Preapplication Safety Evaluation Report for the Sodium Advanced Fast Reactor (SAFR) Liquid-Metal Reactor

U.S. Nuclear Regulatory Commission

Manuscript Completed: September 1991
Date Published: December 1991

This safety evaluation report (SER) presents the results of a preapplication design review for the standard modular Sodium Advanced Fast Reactor (SAFR) liquid metal reactor (LMR), NRC Project No. 673. The SAFR conceptual design was submitted by the U.S. Department of Energy (DOE) in accordance with the U.S. Nuclear Regulatory Commission's (NRC) "Statement of Policy for the Regulation of Advanced Nuclear Power Plants" (51 Federal Register 24643). This policy provides for early Commission review and interaction with designers and licensees. The standard SAFR design consists of four identical reactor modules, referred to as "power paks," each with a thermal output rating of 900 MWt, coupled with four steam turbine-generator sets. The total electric output is 1400 MWe. The reactors are liquid sodium cooled and use metallic-type fuel, a ternary alloy of U-Pu-Zr. The design includes passive reactor shutdown and decay heat removal features.

Figure A.4 SUPERSYSTEM code prediction for SAFR 20c UTOP:
Power and core flow.

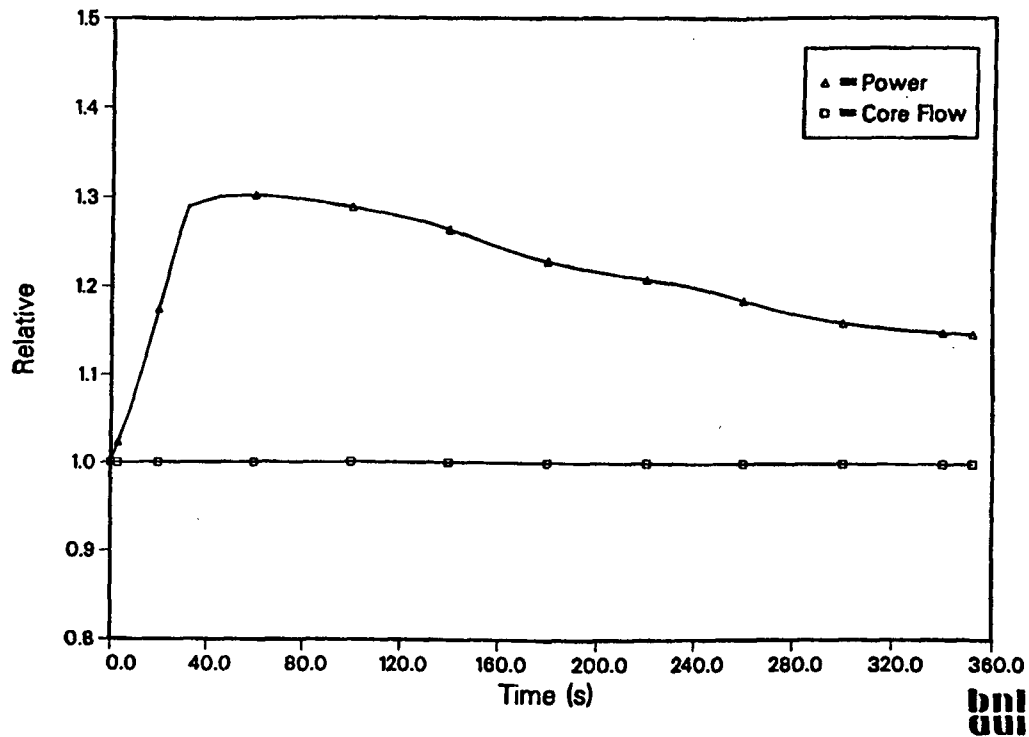
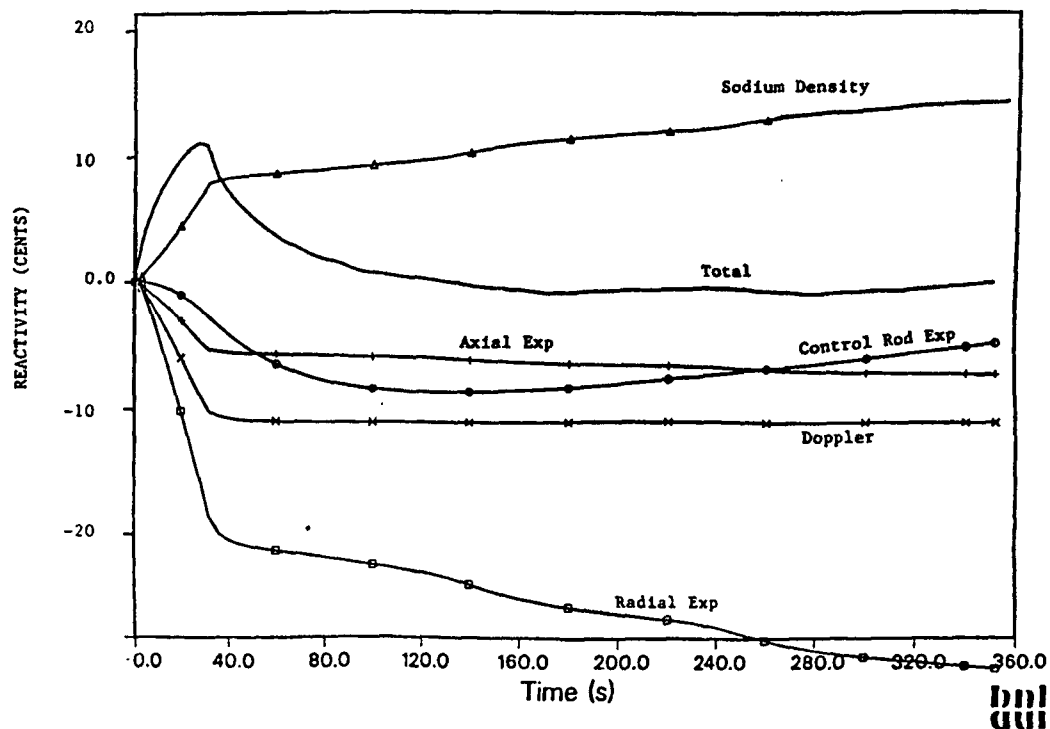
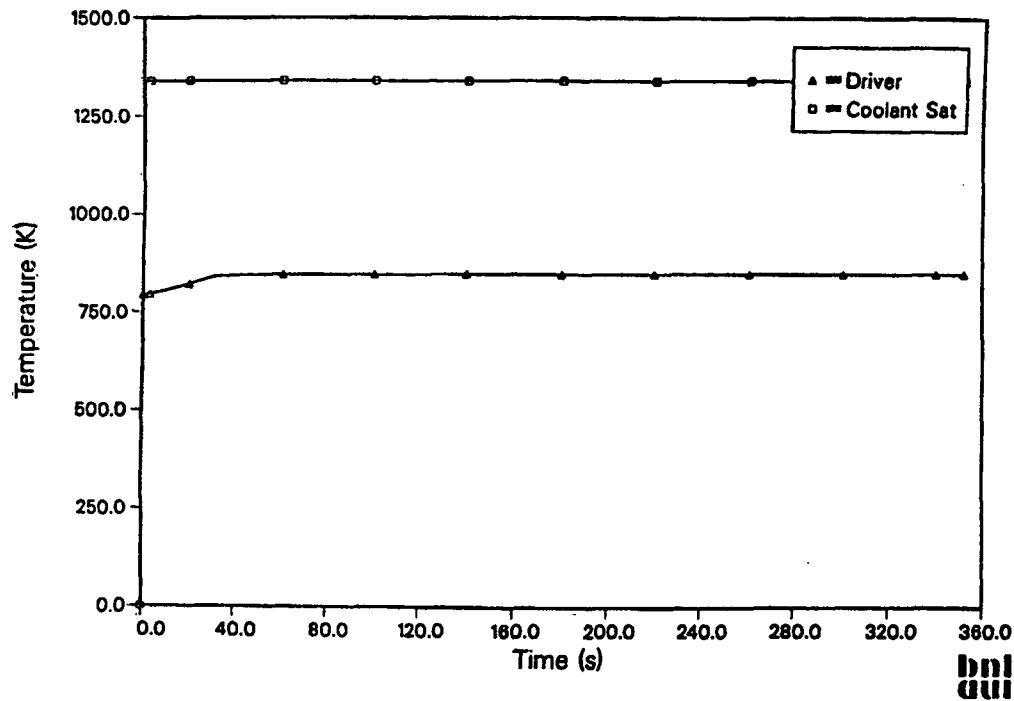
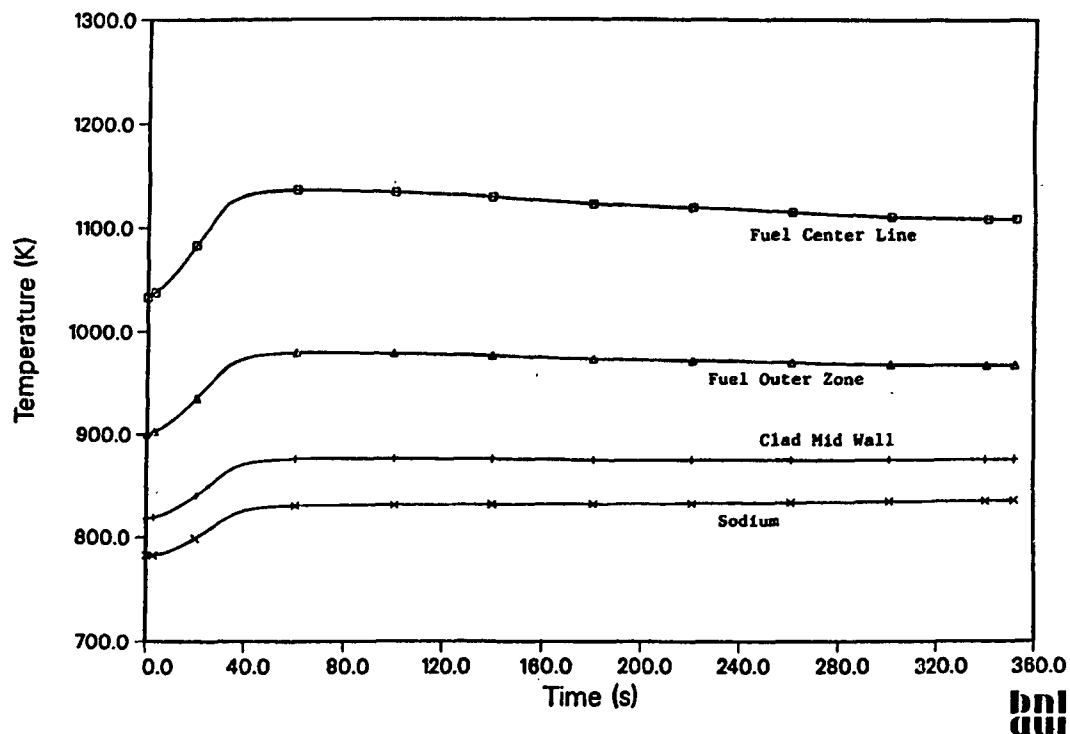
The results are shown in Figures A.4 through A.7. The power is shown in Figure A.4 to rise to 130 percent and return to a quasi-static power level of 115 percent by 160 seconds when criticality is reestablished (see Figure A.5). ANL predicted the power peak at the same level; but the power then drifted down to 104 percent. The difference comes from the control rod drive line expansion feedback, which ANL shows to initially go to -7¢ while the SUPERSYSTEM prediction goes to -4¢ and then approaches zero from vessel expansion. The other feedbacks match the ANL calculations very closely.

The sodium and peak fuel centerline temperature are comparable in both calculations. In Figure A.6, the peak sodium temperature in the core is shown to reach 870 K (1107°F); the ANL results go to 880 K (1125°F). The margin to boiling is predicted by both codes to be about 470 K (846°F). The peak fuel centerline temperature is shown in Figure A.7 to be 1138 K (1589°F), which compares well with the 1111 K (1540°F) predicted by ANL. The margin to fuel melting (not including the migration effects of zirconium) is 228 K (411°F). All margins are thus predicted to be adequate.

The SAFR module appears to be capable of withstanding a 20¢ TOP indefinitely since the elevated power and temperature pose little challenge to core margins. It should be noted (see Figure A.5) that the Doppler feedback inserted about 6¢ for this event while the radial expansion feedback supplied about -15¢ by 300 seconds and is clearly the dominant negative feedback mechanism. This suggests that TOP events can be mitigated as long as the rate of reactivity insertion is within the time constant for the radial feedback.

Figure A.8 SUPERSYSTEM code prediction for SAFR 36c UTOP:
Power and core flow.

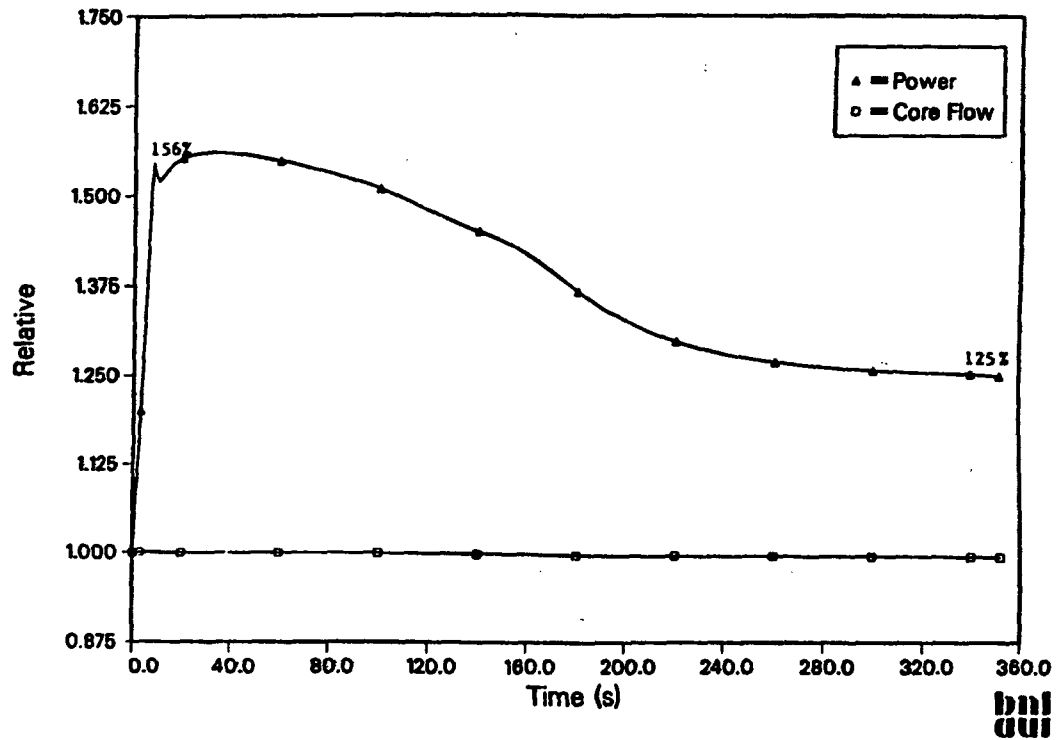
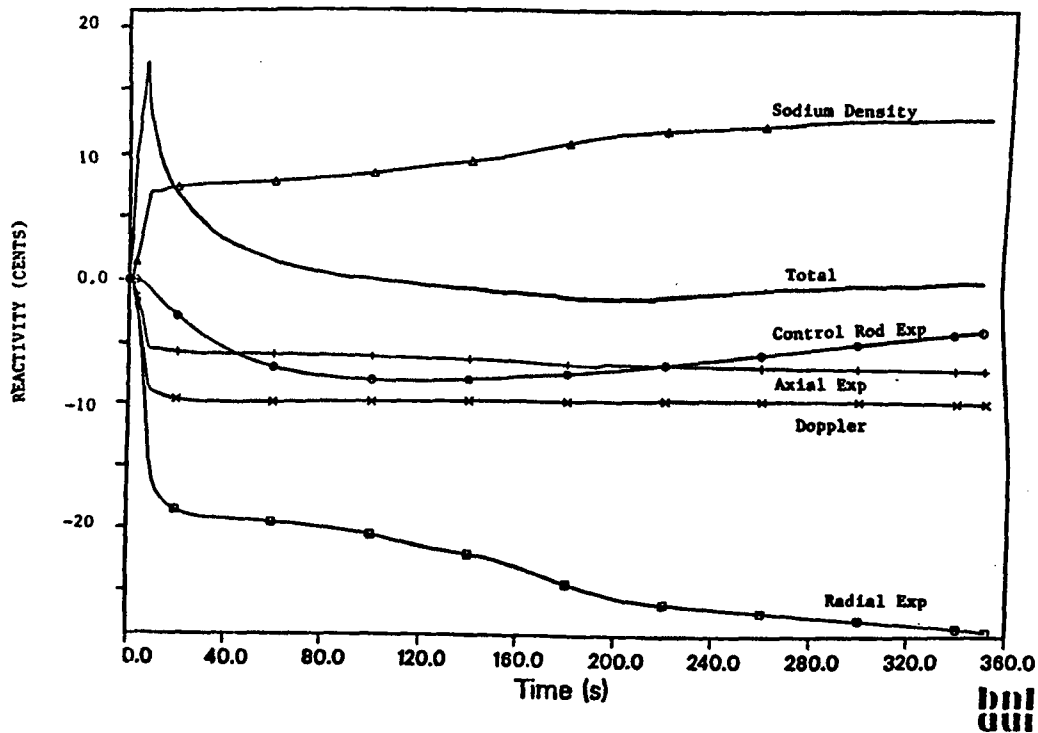
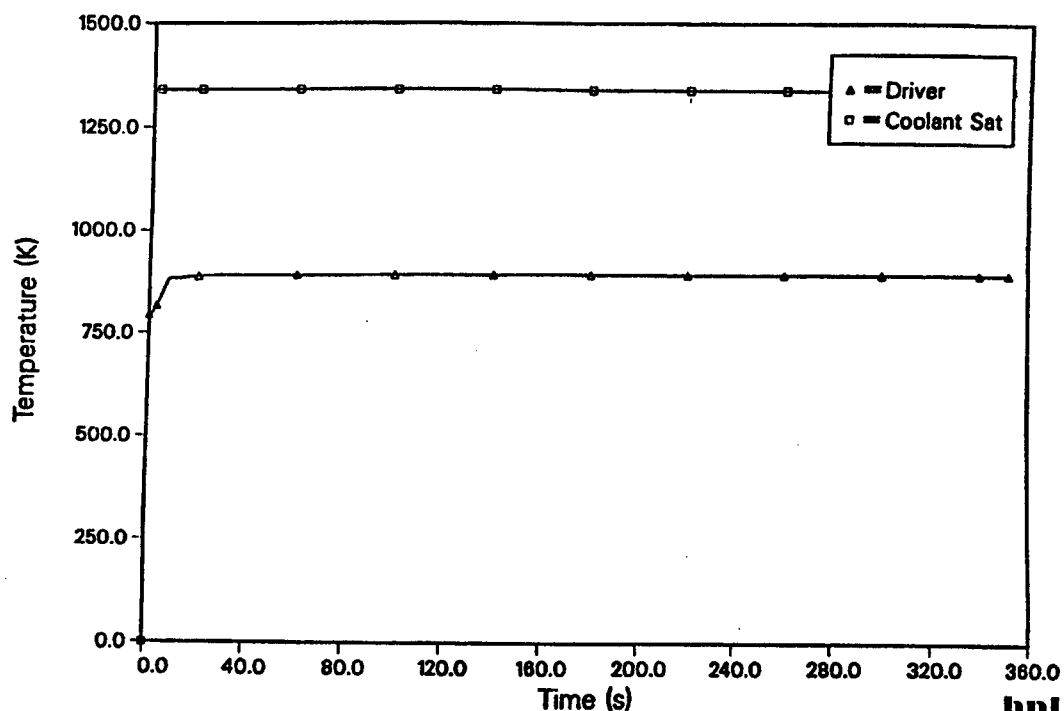
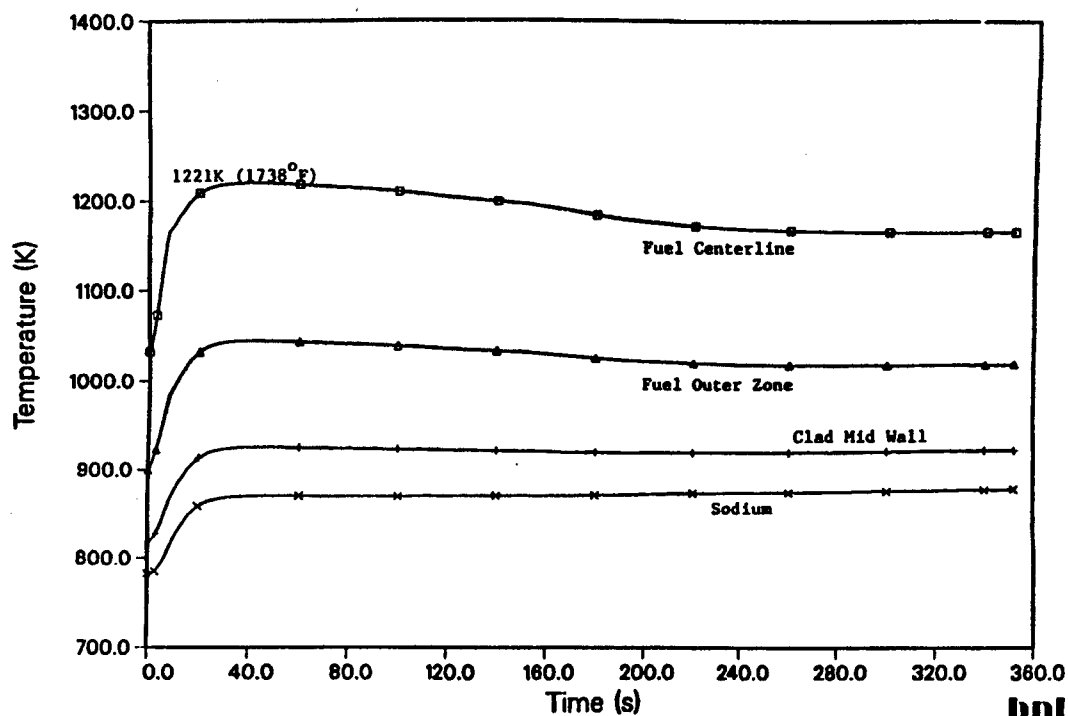
The SUPERSYSTEM results are shown in Figures A.8 through A.11. The power, as shown in Figure A.8, is predicted to reach 156 percent of nominal and slowly reduce to nominal conditions. The results closely match those of ANL in which power peaked at 154 percent and was at 120 percent by 350 seconds. For the same times, SUPERSYSTEM predicted the power to be at 156 percent and 125 percent, respectively. The transient simulation was terminated at 350 seconds since the peak fuel and cladding temperatures had already been exceeded, and the power level was continuing to decrease. The reactivities plotted in Figure A.9 also match within a few cents those predicted by ANL, except for the control rod drive expansion feedback. The SUPERSYSTEM predictions indicated that the reactor vessel was elongating and withdrawing the control rods from the core; the ANL plots indicate no vessel expansion by the constant control rod feedback. This effect caused the different rates of power reduction between the calculations. However, the effect is small, and both codes show the same trends.

In Figure A.9, the total reactivity is the sum of all of the components. The radial feedback is the largest of the negative feedback effects, while the second largest is the sodium density effect, the only major positive feedback. The Doppler feedback generated about -7¢, while the radial expansion was worth -25¢ by 350 seconds. Thus, the power history of the TOP event is basically controlled by the radial expansion feedback.

The margins to sodium boiling and fuel melting were substantial in this calculation. The peak sodium temperature in the core is shown in Figure A.10, where it is plotted against the saturation temperature. The results show that the temperature is about 895 K (1152°F), which gives a margin of 445 K (801°F). ANL predicted peak sodium temperature as 921 K (1200°F). The peak fuel center line temperature was calculated to be 1221 K (1738°F) using SUPERSYSTEM, which is higher

Figure A.12 SUPERSYSTEM code prediction for SAFR ULOHS: Power and core flow.

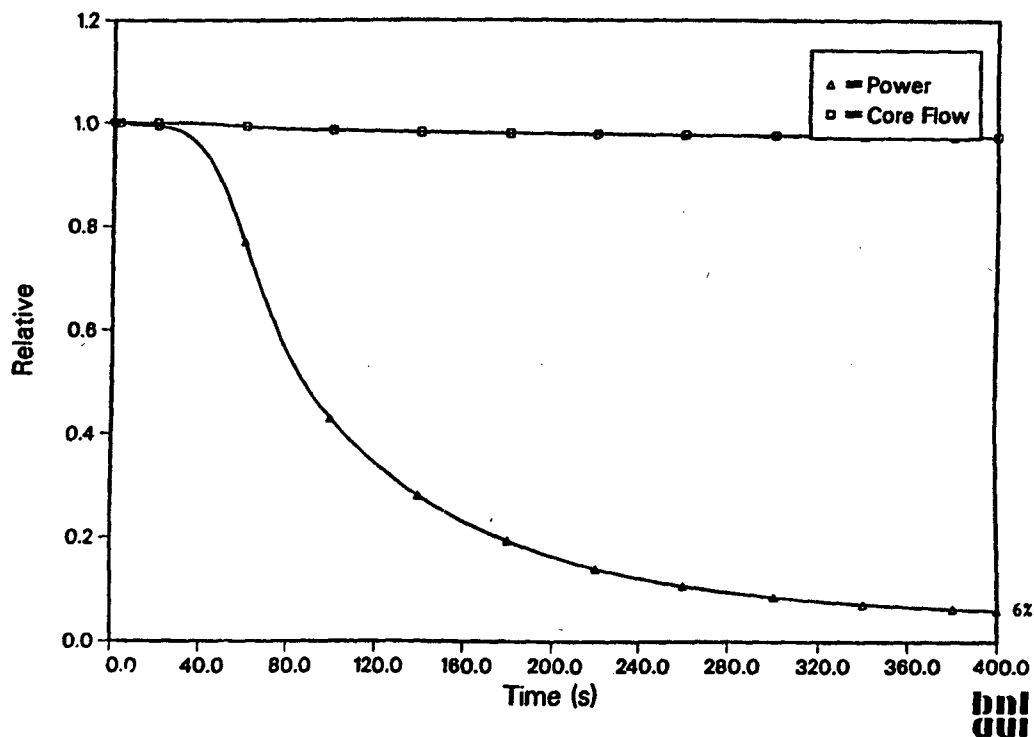
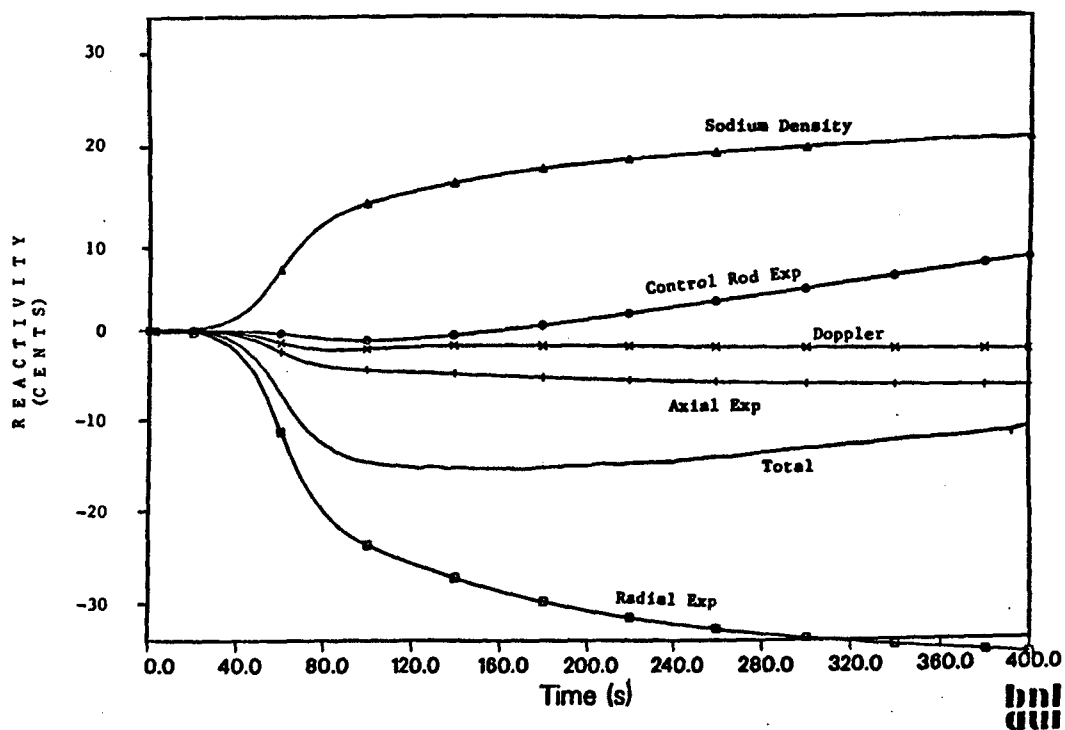
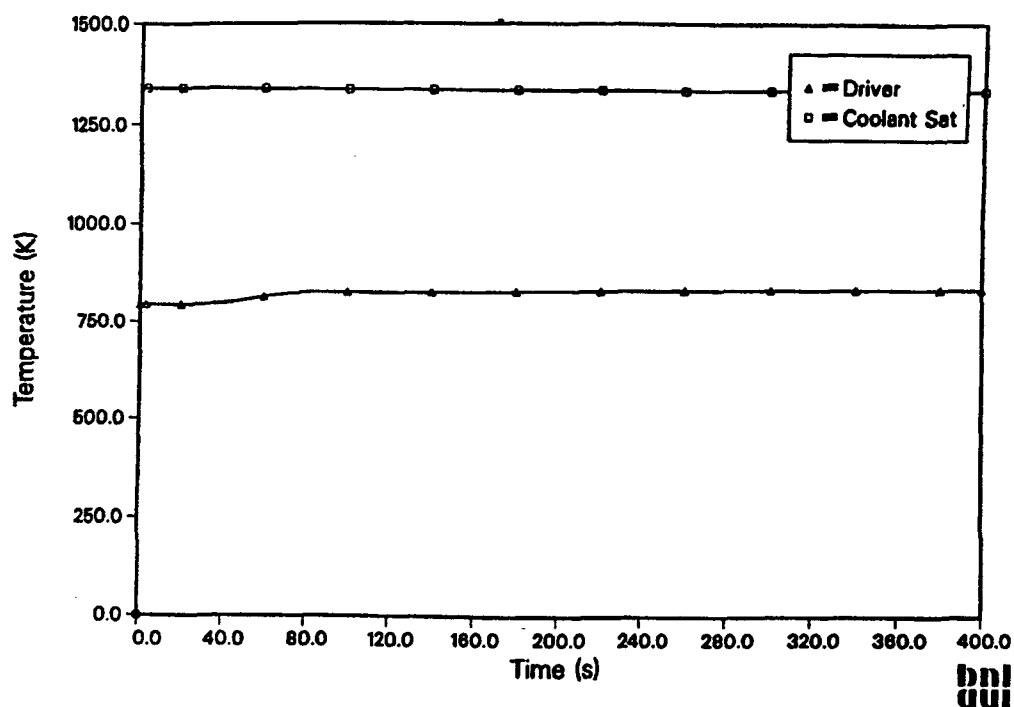
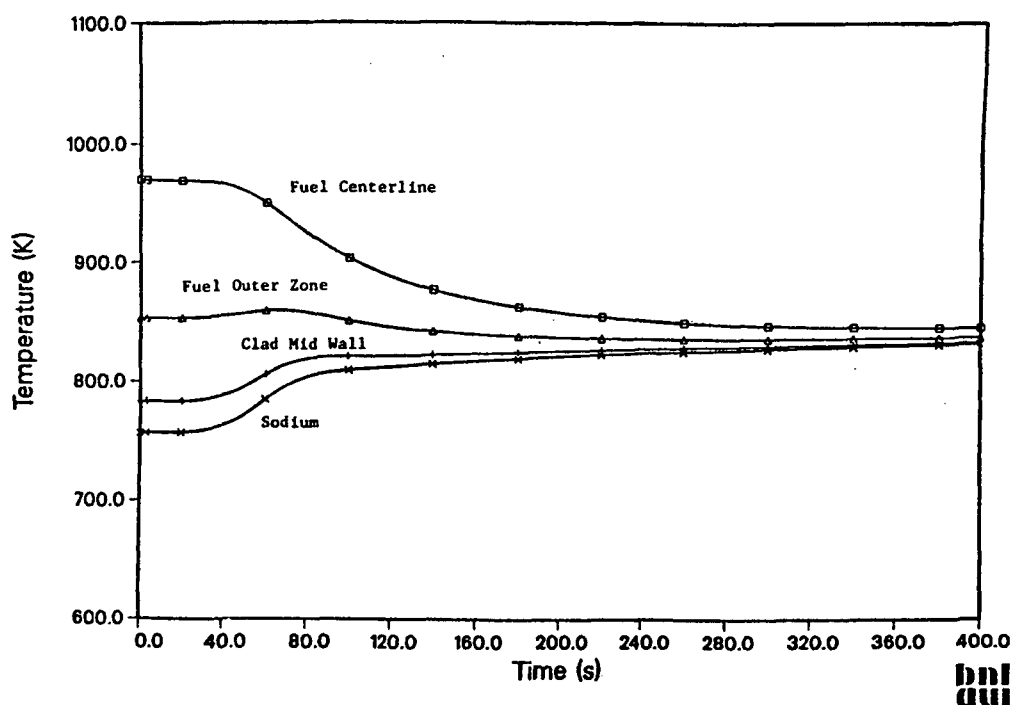
The SUPERSYSTEM predictions are shown in Figures A.12 through A.15. The power, as shown in Figure A.12, drops from rated conditions to about 6 percent by 400 seconds. The reactivity feedbacks are shown in Figure A.13. The positive feedback from the sodium density is initially nullified by the negative feedback from the radial expansion. This is expected, since heat rejection is lost at the steam generators, allowing the heat to be dissipated throughout the system. Having such a large thermal dump dampens the thermal front.

From Figure A.13 it can be seen that the control rod drive line feedback begins a few cents negative. The time constant for this is 28 seconds. The reactor vessel also begins to thermally expand (because of increased temperatures) at a rate corresponding to its 750-second time constant, withdrawing the control assemblies from the core and causing a positive feedback. SUPERSYSTEM predicts this to be worth +10¢ by 400 seconds.

The peak temperatures for this event do not challenge the system. Figure A.14 shows the peak sodium temperature plotted against the saturation temperature, and shows that the temperature increase during the event is small. The margin to boiling is 507 K (913°F). The resultant peak fuel temperature history during this event is presented in Figure A.15 which shows that fuel center line (as well as the rest of the fuel) temperature decreases as the power drops.
